Agenda Report 2017-05-08-02

Subject: AP-17-01 - Appeal of reconsideration decision to approve 18000 Upper Midhill Subdivision.

The purpose is to hold a public hearing to consider Jason and Jessica Harra's appeal (AP-17-01) of the March 22, 2017, Planning Commission (Commission) reconsideration decision to approve a 34-lot subdivision at 18000 Upper Midhill Drive.

Enlargement of Figure 9 above: Proposed interim mitigation plan (north end)

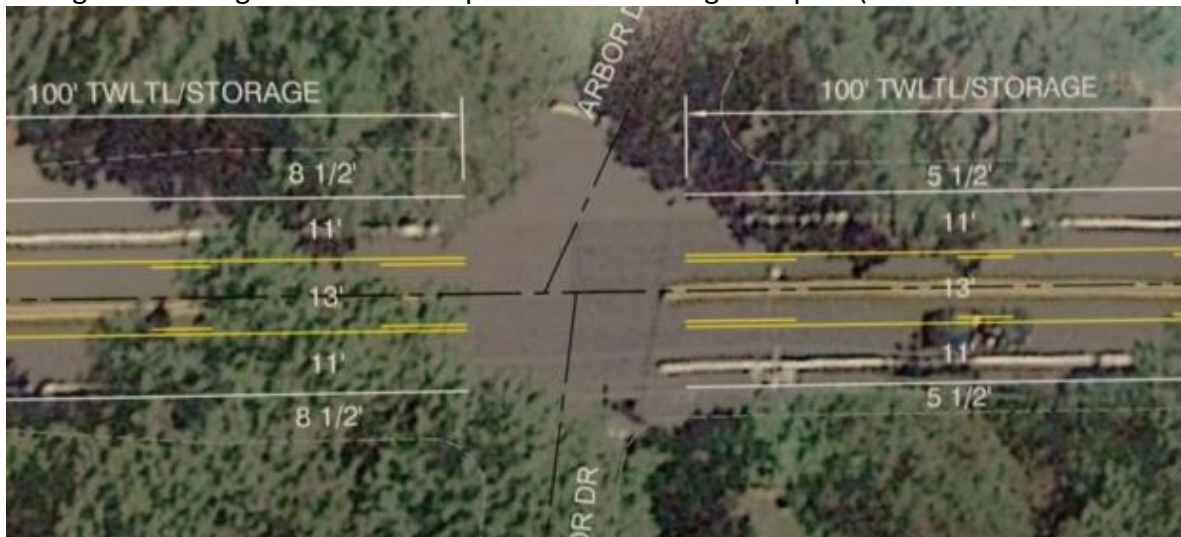
Exhibit CC-B2 includes the applicant's proposed interim mitigation plan as submitted at the March 22, 2017 Planning Commission hearing. It shows that the existing bike lane width is 5.5 feet on the west side and 7.5 feet on the east side for 163 feet, where Willamette Drive crosses Arbor Creek. The bike lane width for the remainder of Willamette Drive beginning near the Arbor Drive intersection and extending south is 7.5 feet on the west side and 9 feet on the east side.

Exhibit CC-B2 also shows the applicant's proposed interim mitigation plan will affect a 580 foot section of Willamette Drive starting in the vicinity of the concrete barriers next to Arbor Creek 200 feet north of the Arbor Drive intersection and terminating 380 feet south of the intersection. The interim mitigation plan, with a left turn refuge, shows a bike lane width of 5.5 feet on each side of Willamette Drive.

Staff recommends that City Council consider denying this ground for appeal based on the fact that ODOT supports the applicant's proposed interim mitigation design and that the narrow bike lane width may be allowed under ODOT's Design Exception program and that this narrower width is only an interim solution until the West Linn OR 43 2016 Conceptual Design Plan is completed circa 2020.
